Service Bulletin

Bulletin No. 2010-65
CMD 2010-05

Global Positioning System (GPS) Receivers Exhibit Slow Startup

Identification decals with revision numbers

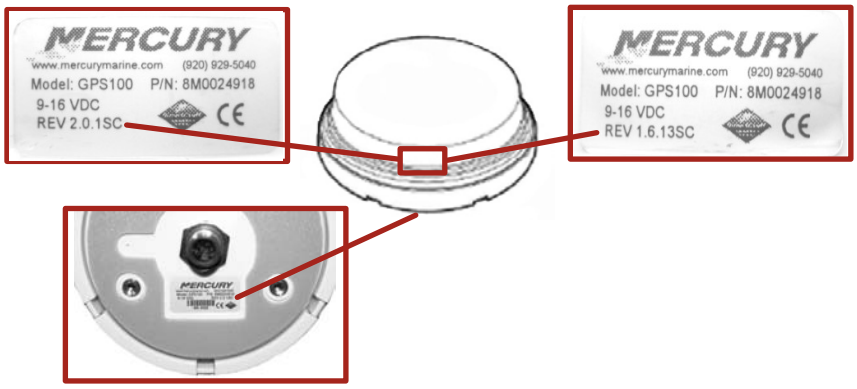
Zeus or Diesel Axius equipped vessels using GPS units with part number 8M0024918 have either REV 1.6.13SC or REV 2.0.1SC receiver module software. Units with REV 2.0.1SC software are less sensitive to GPS signals and could experience longer than normal times to acquire satellites resulting in delayed functions of premier features.

The GPS revision (REV) number is located on the identification decal affixed to the side of the unit or the serial plate on the bottom.

Determine the software version of the GPS unit by reading the REV number on the identification decal or serial plate. As an alternative, you can use the VesselView by selecting Vessel Personality under VesselConfig and locating the REV number.

If the vessel is equipped with REV 2.0.1SC software replace it with a GPS unit with REV 2.2SC software. Order the correct GPS unit by the corresponding part number for your Axius or Zeus equipped vessel.
